# Work Order ID 97867

Item Name: Crosstube Turning Detail

DRAWING NO. D212-664-241	TITLE CROSSTUBE ASSY (205/212 HI AFT)	REV. D	DART AEROSPACE LTD ENGINEERING ORDER		D.E.O. NO. D212-664-241-D-1	SHEET NO. SHEET 1 OF 2	SCALE NTS
DRAWN	CHECKED	MFG. APPR.	APPROVED	DE APPR.			
DATE 11.04.07	DATE 11.04.11	DATE 11.04.12	DATE 11/04/12	DATE 11.04.12

DRAWING NO. D212-664-241	TITLE CROSSTUBE ASS'Y (205/212 HI AFT)	REV. D	<b>DART AEROSPACE LTD ENGINEERING ORDER</b>	D.E.O. NO. D212-664-241-D-2	SHEET NO. SHEET 1 OF 1	SCALE NTS
DRAWN 97	CHECKED ASS	MFG. APPR. [Signature]	APPROVED [Signature]	DE APPR. [Signature]		
DATE 11.07.15	DATE 11.07.20	DATE 11.07.21	DATE 11.07.21	DATE 11.07.21

**D212-664-241/-241B  
ASSEMBLY DETAIL**

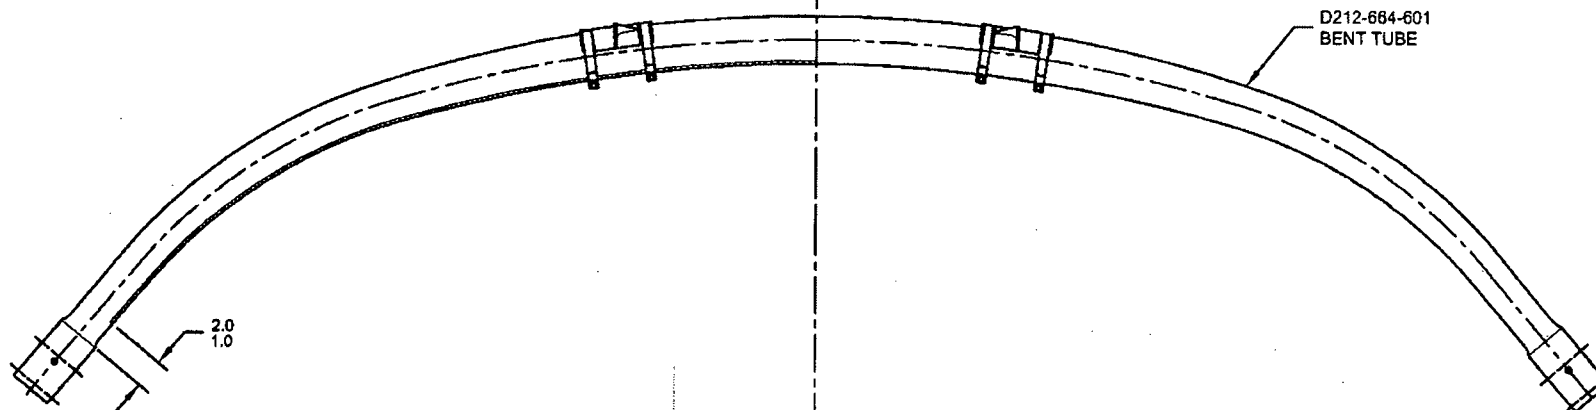
**PURPOSE:**

ADD AN INSPECTION WINDOW TO UNDERSIDE OF CROSSTUBE.

- 2) FINISH: CHEMICAL CONVERSION COAT PER DART QSI 005 4.1  
PRIME INSIDE AND OUTSIDE PER DART QSI 005 4.2  
MASK UNDERSIDE OF CROSSTUBE AS SHOWN (HATCHED AREA) AND  
PAINT OUTSIDE PER DART QSI 005 4.2  
REMOVE MASKING AND APPLY CLEAR COAT

- 2) FINISH: CHEMICAL CONVERSION COAT PER DART QSI 005 4.1  
PRIME INSIDE AND OUTSIDE PER DART QSI 005 4.2  
PAINT OUTSIDE PER DART QSI 005 4.2

MASK AREA PRIOR TO PAINTING,  
REMOVE MASKING AFTER PAINT  
AND APPLY CLEAR COAT
